**STAFF REVIEW COMMITTEE AGENDA**  
**BRUNSWICK TOWN HALL**  
**85 UNION STREET**  
**Friday, August 7, 2020, 10:00 A.M.**

- 1. Case #20-027 Maine Blue Shellfish, INC:** The Staff Review Committee will review and take action on a **Minor Development Review Sketch/Final Plan** application submitted by Burnham and LoboZZo Builders LLC on behalf of Maine Blue Shellfish, INC to build a 1,900 square foot shellfish storage and distribution facility. The subject lot (Map 42, Lot 7) is within the **GM4 (Growth Mixed-Use 4) Zoning District**.
- 2. Other Business**
- 3. Adjourn**

2. Project Name: Maine Blue Shellfish, INC

## DRAFT FINDINGS OF FACT FINAL PLAN MINOR DEVELOPMENT REVIEW

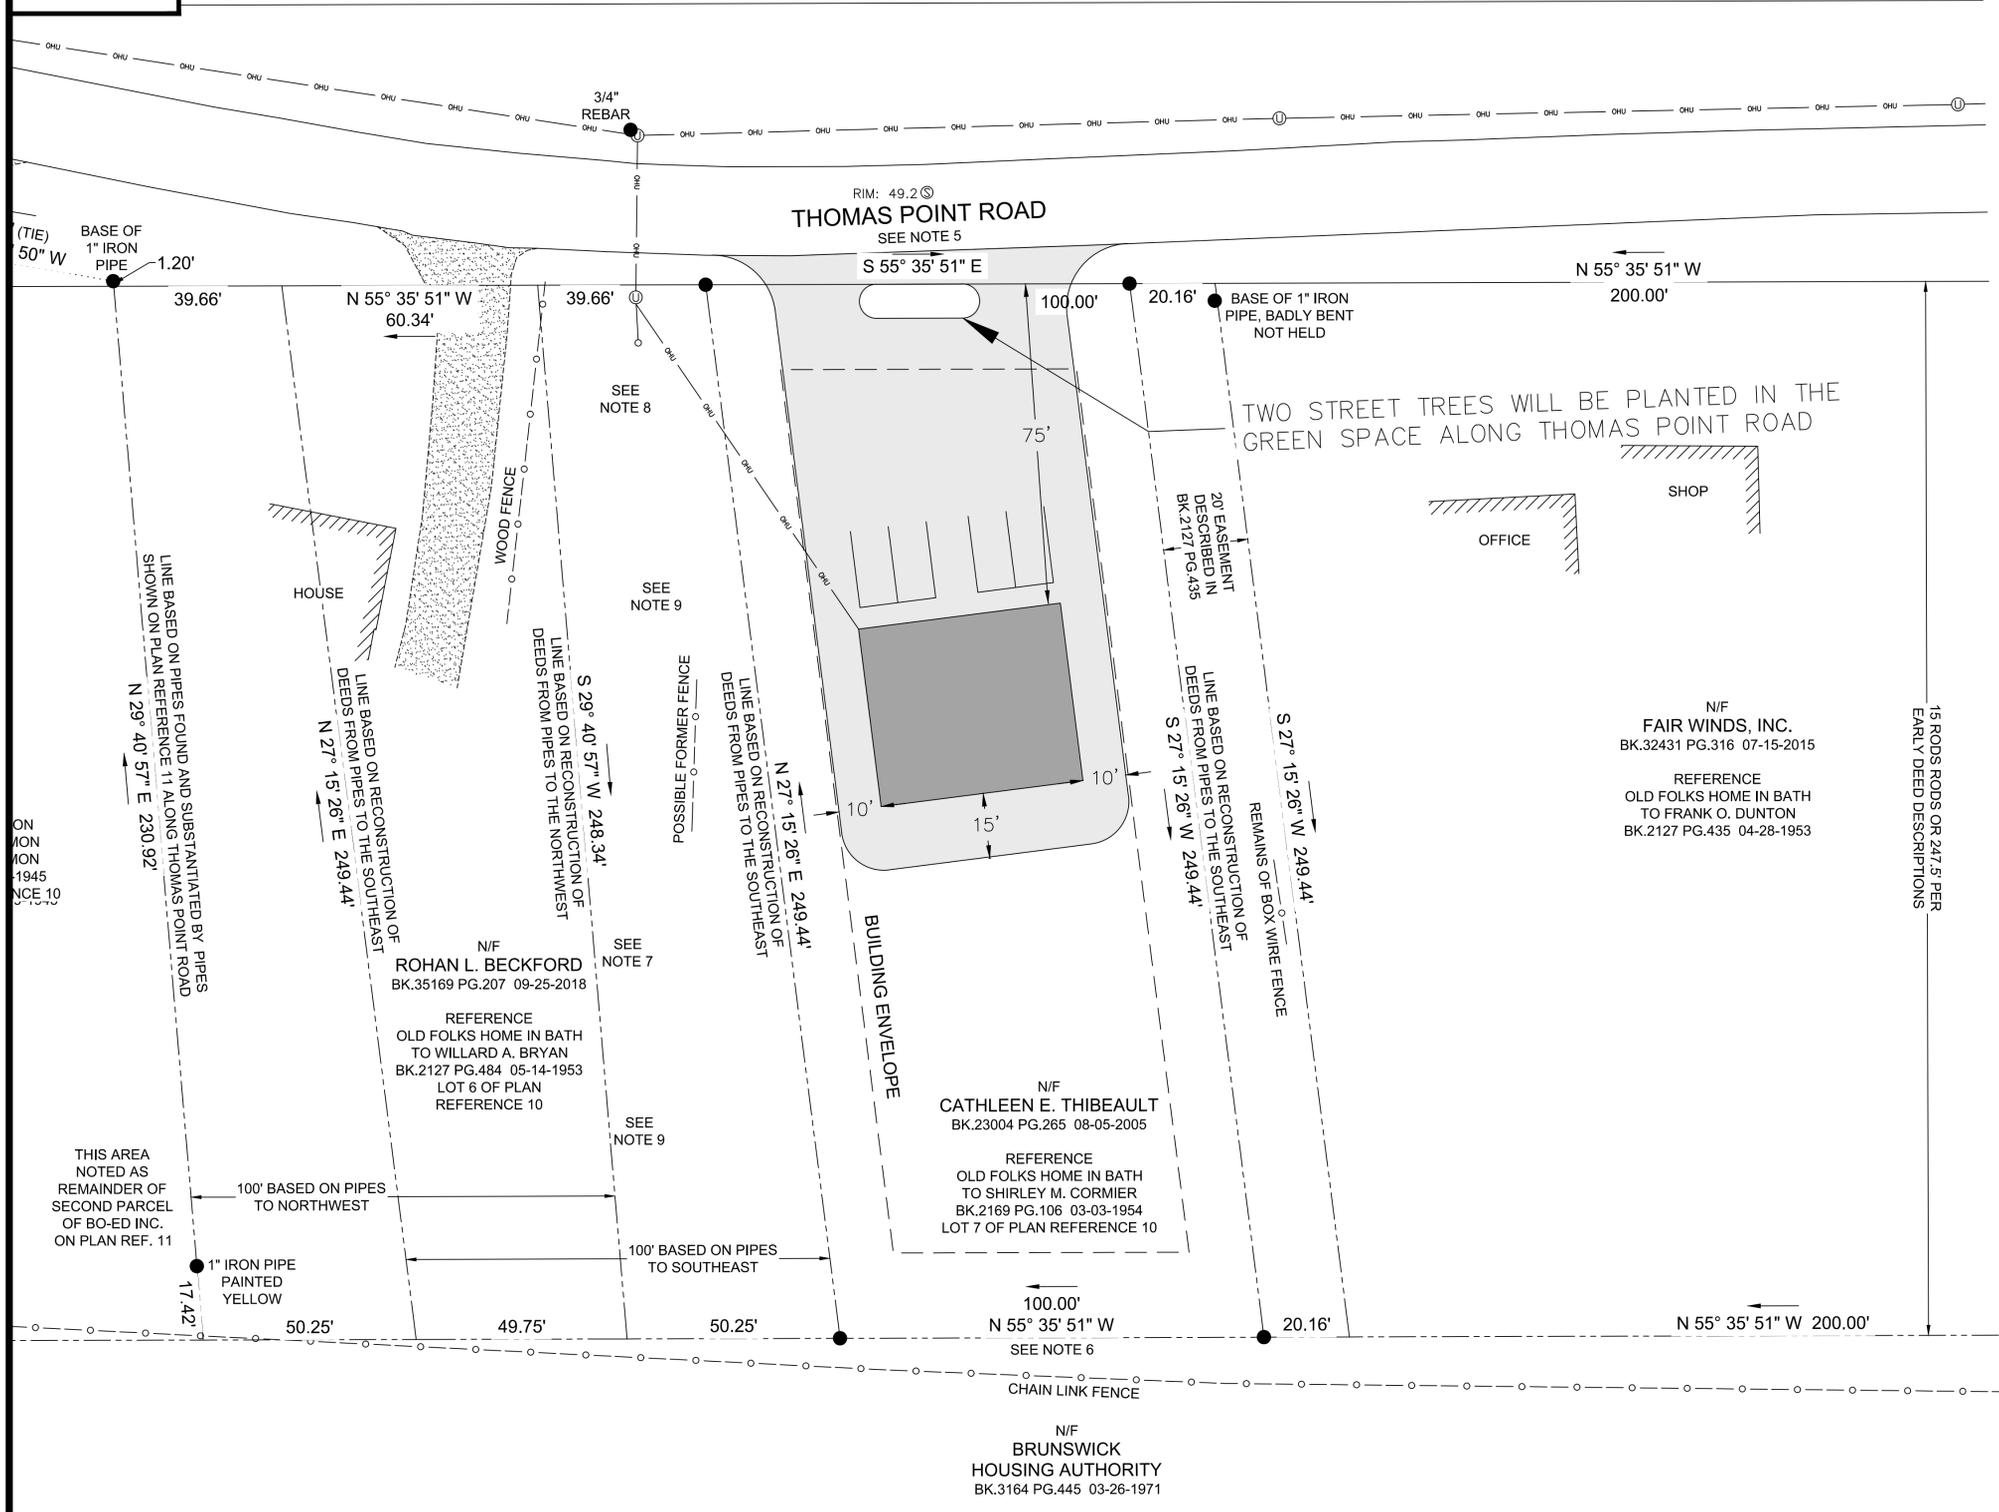
A note requiring two street trees and the parking spaces are on the Proposed Development Plan.

Staff note fire hydrants are near the project site as depicted on the town GIS database. Nevertheless, staff advise consultation with the Fire Chief or designee to develop and implement a plan to provide water for the purpose of fire protection in accordance with subsection 4.5.2.D, "Specific Standards: Fire Protection Water Supply." Staff advise a
